SECY-83-98E

SUBJECT: SALEM RESTART EVALUATION

NRC SAFETY EVALUATION
RELATED TO PLANT RESTART
PUBLIC SERVICE ELECTRIC & GAS COMPANY
SALEM NUCLEAR GENERATION STATION
UNIT NOS. 1 AND 2
DOCKET NOS. 50-272 AND 50-311

Figure 1. Unit 2 "B" Undervoltage Trip Attachment
(A, C, and D are photographs of the as-received condition.)

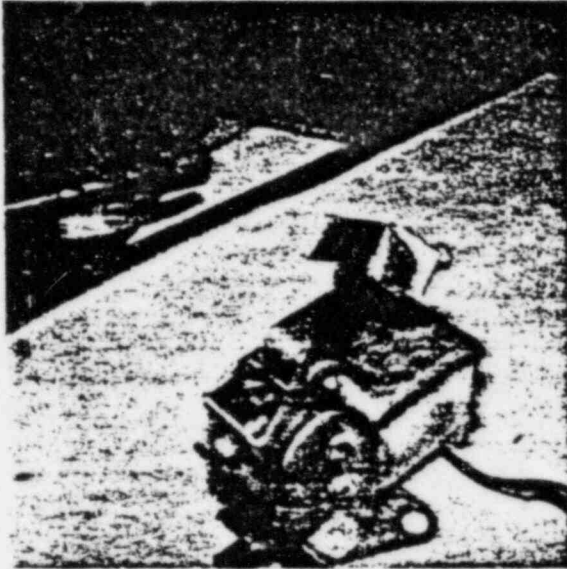
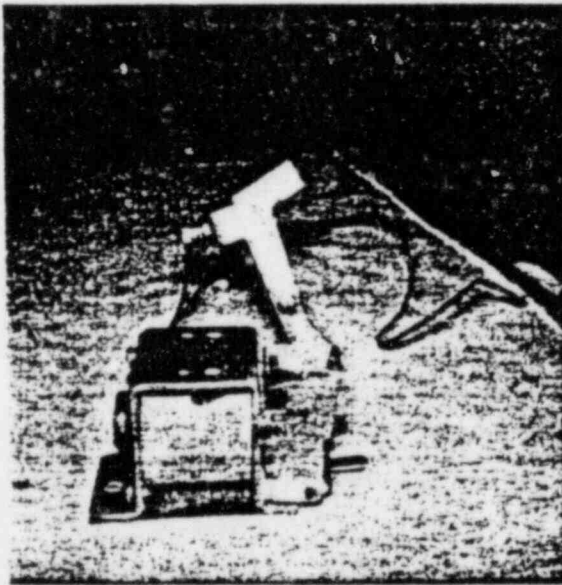
The Salem 2 "B" UV trip attachment consistently tripped at 12.6 ± 0.4 Volts dc when voltage was gradually reduced from 48 Vdc. This is 26% of normal operating voltage. It was noted that the reset arm moved partially towards unlatching a few volts before unlatching occurred indicating binding of the latch to latch pin.

3. The adjustment for spring tension for the reset lever spring was found on the Salem 2 "B" UV Trip attachment to be approximately $1\frac{1}{2}$ turns below the surface of the locking nut. The adjustment was brought to the condition shown on Fig. 17 of the Westinghouse Manual, "Instructions for Types DB-50, DBF-16 and DEL-50 Air Circuit Breakers," which is approximately 6 turns beyond the surface of the locking nut. (See attached drawing.) The UV trip attachment then operated at 25.8 Vdc, which is 54% of normal voltage. When tension was reduced to the lowest limit (1 to $1\frac{1}{2}$ turns below the as-found condition) the device operated a 6.3 Vdc or 13% of voltage.
